STATEMENT OF GORDON J AHALT IN OPPOSITION TO THE GRANTING OF A REASONABLE USE EXCEPTION IN CASE CA015-001 & VARIANCE18-002 - May 20, 2020

RE: GEOTECHNICAL THIRD-PARTY REVIEW, 5637 EAST MERCER WAY,
CITY OF MERCER ISLAND PROJECT NO. CAO15-001

EX. AH-2

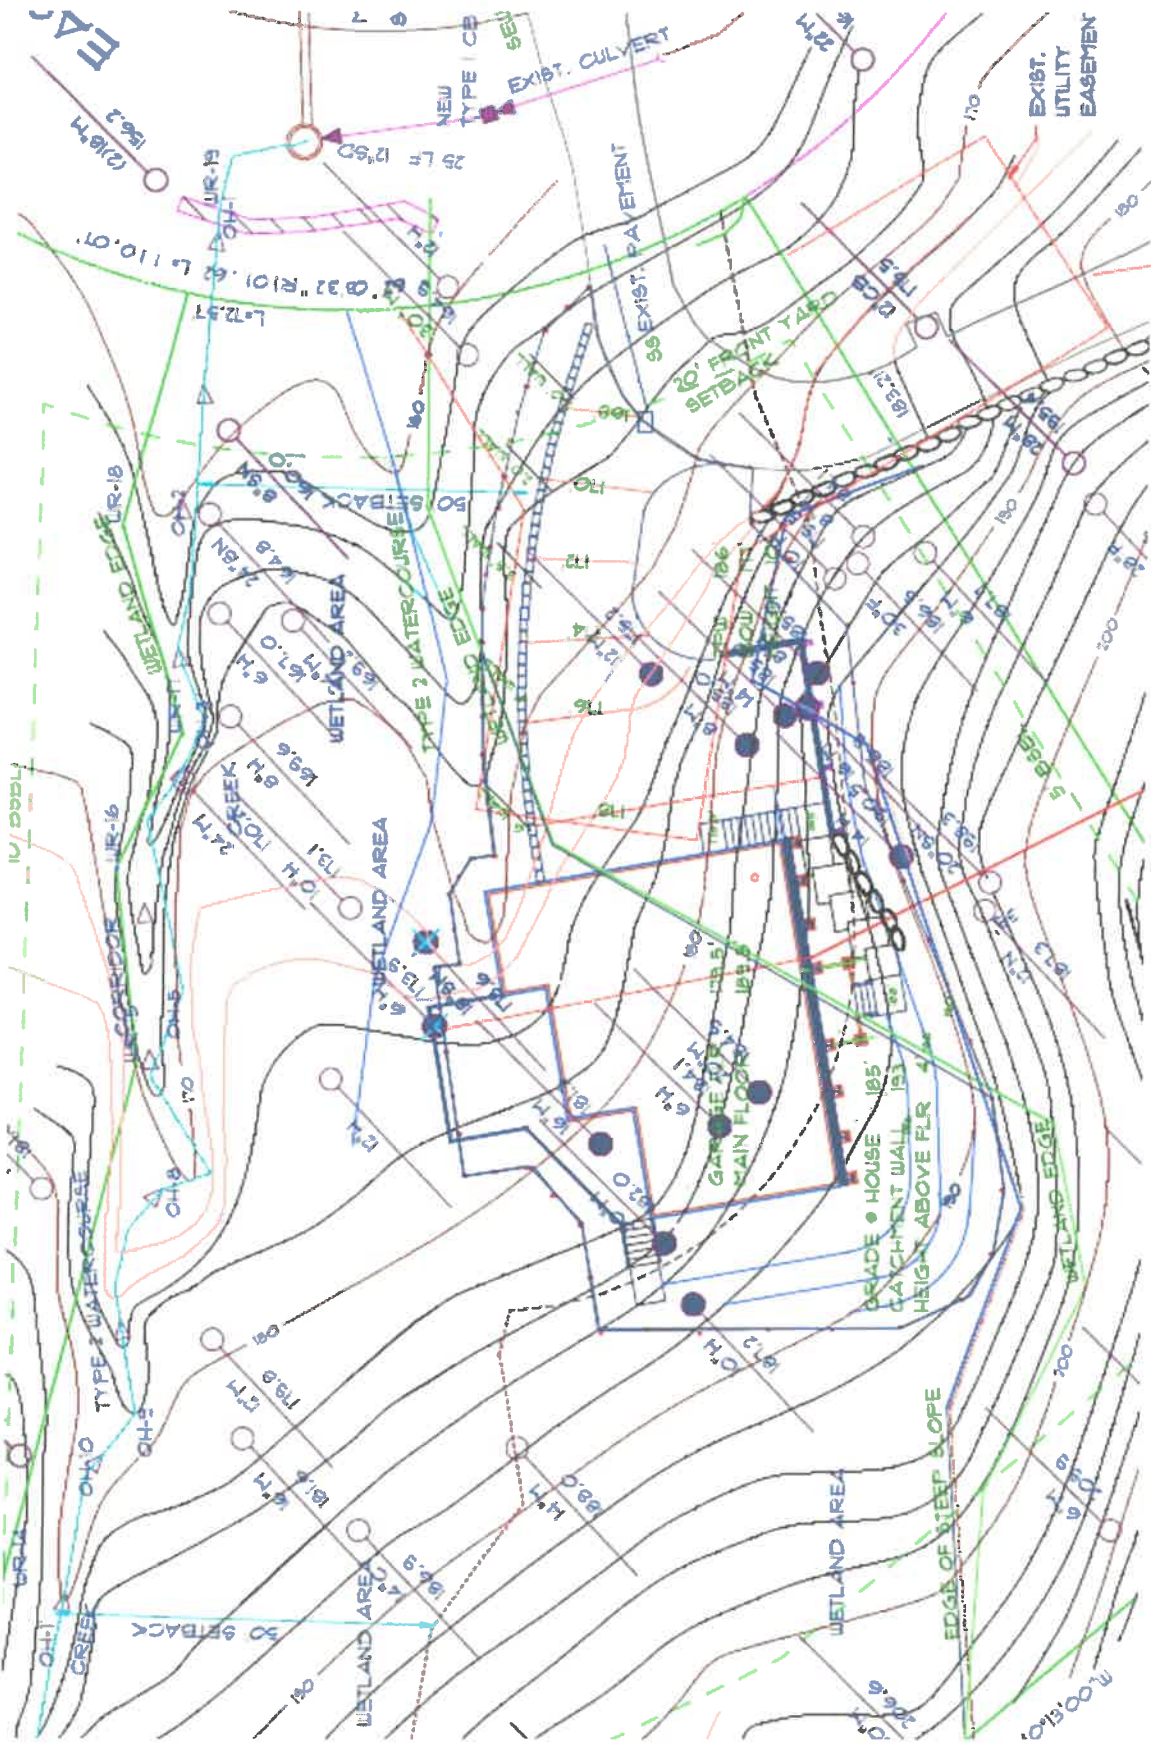
- 2) The site plan for the property by Healey-Jorgensen dated May 25, 2018 (attached as Ex. AH-2) depicts the location of the southern Type 2 Watercourse, which originates in the center of the wetland, approximately 25’ further north than the Healey-Jorgensen site plan dated Oct. 17, 2016 (attached as Ex. AH-3). An enlargement of the May 25, 2018 site plan (attached as Ex. AH-4) makes it easier to see the location of the southern stream depicted in this site plan. The May 25, 2018 site plan is the proposed site plan by the Applicant today.

Attached is Ex. AH-5 which is an enlargement of the site topo and site plan where I have highlighted in yellow the southern Type 2 Watercourse depicted by Healey-Jorgensen in the May 25, 2018 site plan (Ex. AH-2), and I highlighted in green where Healey-Jorgensen depicted the location of the southern Type 2 Watercourse in the Oct. 17, 2016 site plan (Ex. AH-3) and where it was depicted in prior site plans until the change in May 25, 2018. Note that the yellow location further north and away from the proposed house does not follow the V in the contour lines depicting the lowest elevation points but rather has the stream flowing at a higher elevation along a ridgeline that separates the northern and southern Type 2 Watercourses. The green hash line shows the location of the southern Type 2 Watercourse as depicted in Healey-Jorgensen site plans up to and prior to their Oct. 17, 2016 site plan (Ex. AH-3).

Therefore, it appears the southern Type 2 Watercourse depiction in the May 25, 2018 site plan (Ex. AH-2) was done without the benefit of a survey to confirm the actual location. This conclusion is further supported by the email from Michael Moody dated May 22, 2018 (Ex. AH-8) where he concludes it is better for Core Design to do a new survey rather than use the CHS survey because of inaccuracies he sees in the CHS survey. Clearly Core Design did not do a new survey before the Healey-Jorgensen May 25, 2018 site plan was completed as Core Design did not have the prior CHS files until May 31, 2018.

A visual inspection of the property will show that the southern Type 2 Watercourse is not accurately depicted in the most recent Healey-Jorgensen site plan because it is easy to see that the stream does not flow down the middle of the ridgeline that separates the northern and southern Type 2 Watercourses, and also because the most recent site plan shows the southern Type 2 Watercourse on the north side of two large trees, whereas, the site plans up to and prior to May 25, 2018 show the southern Type 2 Watercourse on the south side of the same two large trees. This can be seen in Ex. AH-2, Ex. AH-3, and Ex. AH-5.

A visual site inspection will also show any observer that the gross area of the Category III Wetland depicted in the Healey & Jorgensen site plan is grossly understated. The site plan excludes a large area of the wetland on the southeast side of the property where it adjoins the Stivelman property. The applicant represents that the southeast corner, representing approximately 245sf, will not be in the wetland and that this is a significant reduction of intrusion in the wetland from the prior site plan. The reality is the wetland border is not accurate and 100% of the proposed house foundation will be in an existing wetland where there is running surface water coming out of the steeply sloped hillside from Stivelman's property. I would also argue that a 245sf reduction in the wetland intrusion by the proposed home is not a significant reduction.

The Healey-Jorgensen site plan contains a lot of inaccuracies. Topo lines are inaccurate as stated by Core Design, the southern Type 2 Watercourse has been arbitrarily depicted without a survey, the area of the Category III Wetland has been inaccurately depicted and reduced in size from prior site plans submitted to the City, and this is a very dynamic site where trees fall every year, directional water flows migrate and change, and there is continual siltation of the Ravine from upstream waterflows.
